RE: LORAIN COUNTY
HEIDER DITCH BASIN
CITY OF AVON LAKE
AVON LAKE HIGH SCHOOL STADIUM

On June 15, 2010, Ohio EPA conducted an inspection of the Avon Lake High School Stadium project located at 175 Avon Belden Road, City of Avon Lake, Lorain County (site). Ohio EPA records indicate that the site is covered by the General National Pollutant Discharge Elimination System (NPDES) Permit for Storm Water Associated with Construction Activity (General Storm Water Permit), permit No. 3GC04883*AG. I was accompanied by Chris Moody of Ohio EPA. The inspection documented the following:

Figure 1. No inlet protection has been installed. Large amounts of sediment were observed in the storm sewer inlets.

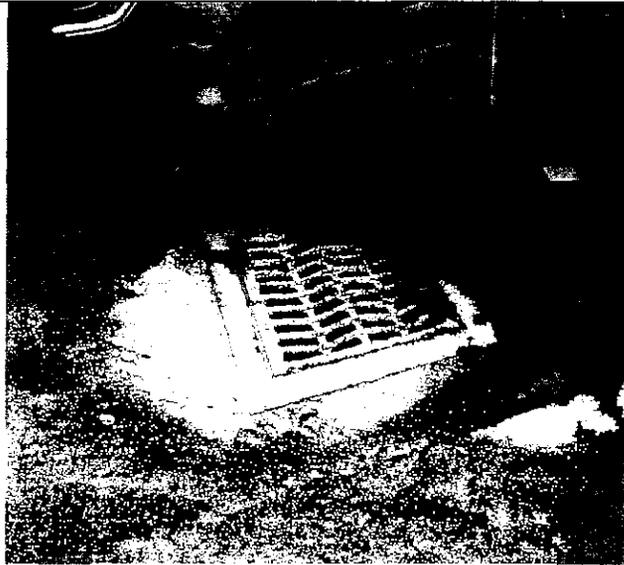
- No inlet protection has been installed (Figures 1 and 2). Heavy sediment deposition was observed in many of the site's storm sewer inlets. Install inlet protection according to the site's SWP3.
